Federal Register

[Docket No. FAA-2008-0071; Directorate Identifier 2006-SW-27-AD; Amendment 39-16291; AD 2010-10-12]

Airworthiness Directives; Bell Helicopter Textron Canada Model 222, 222B, 222U, 230, and 430 Helicopters

AGENCY: Federal Aviation Administration, DOT. **ACTION:** Final rule.

P/N 222-016-001 – all dash numbers Figure 1 Blade Inspection Area

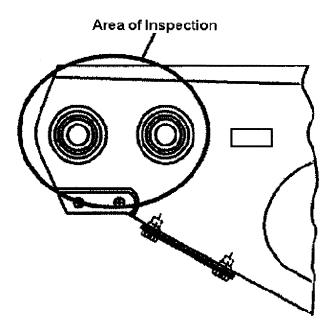
(a) Within 3 hours time-in-service (TIS), unless accomplished previously, and thereafter at intervals not to exceed 3 hours TIS, clean and visually check both sides of each blade for a crack in the paint in the areas shown in Figure

1 of this AD. An owner/operator (pilot), holding at least a private pilot certificate, may perform this visual check and must enter compliance with this paragraph into the helicopter maintenance records by following 14 CFR 43.11 and 91.417(a)(2)(v).

- (b) If the visual check required by paragraph (a) of this AD reveals a crack in the paint, before further flight, remove the blade and follow the requirements in paragraphs (c)(2) through (c)(3)(ii) of this AD.
- (c) Within the next 50 hours TIS, unless accomplished previously, and thereafter at intervals not to exceed 50 hours TIS, clean the blade by wiping down both surfaces of each blade in the inspection area depicted in Figure 1 of this AD using aliphatic naphtha (C–305) or detergent (C–318) or an equivalent. Using a 10X or higher power magnifying glass, visually inspect both sides of the blade in the areas depicted in Figure 1 of this AD.
